CITY OF ST. PETERSBURG, FLORIDA
PLANNING AND DEVELOPMENT SERVICES DEPARTMENT
URBAN PLANNING AND HISTORIC PRESERVATION DIVISION

STAFF REPORT

Certificate of Appropriateness Request

Case No.: 20-90200111
Address: 335 22nd Avenue Northeast

Figure 1: 1951 Sanborn Map of subject property and vicinity; cropped and highlighted by staff.

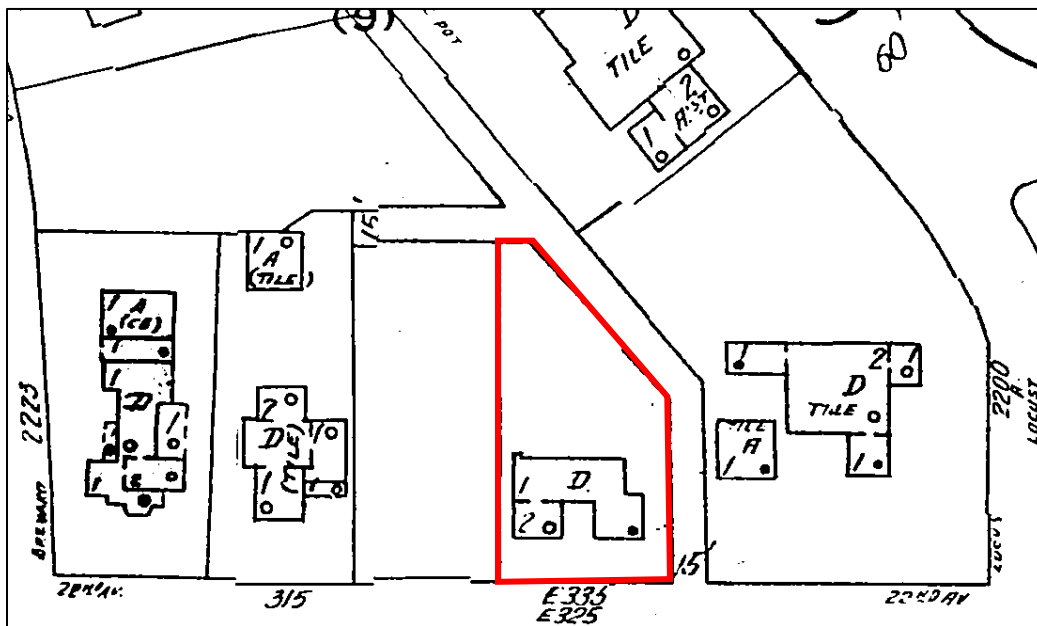
The 1951 Sanborn Map of the area (Figure 1) does not show the current garage on the rear of the house that faces the alleyway. Records do not indicate when the rear garage was constructed. The owner states that when they purchased the property, the garage doors were missing, so they built the ones that are in existence today.

DESCRIPTION: GALLERY 2" PUR SINGLE CAR +38/-44 PSF		
DRAWN BY: MW	DATE: 9/7/95	SCALE: NTS
CHECKED BY: --	DATE: --	SHEET 1 OF 4
DWG. NO.: 104432 - A/B	VER: IBC	SIZE B

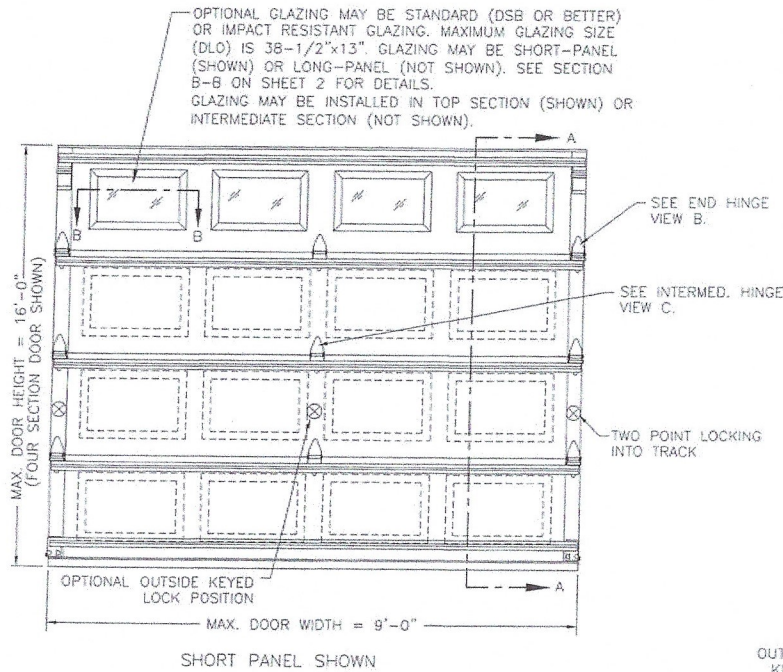
I have taken over your COA application for the garage door replacement at 335 22nd Ave NE from Laura Duvekot. I am reviewing the application, and I am hoping you can help clarify what the proposed garage door will look like. The application material highlights two different models from Clopay (GD2LU and GR2LU). There appears to be many customizable options, and you also mention using black iron hardware. So I want to use an image in the report that accurately depicts the door you want to use.

Can you let me know if the image below is the correct door with the long panels? Will there be windows at the top? Or will they be solid?

Hi Kelly, yes it is the image you sent "gallery collection" with the long panels, walnut grain but without the windows on top. The new door will be mounted behind the existing arch, so windows wouldn't work. It will be adorned with faux black iron hardware and strap hinges, to match the rest of the house. Let me know if you need anything further.
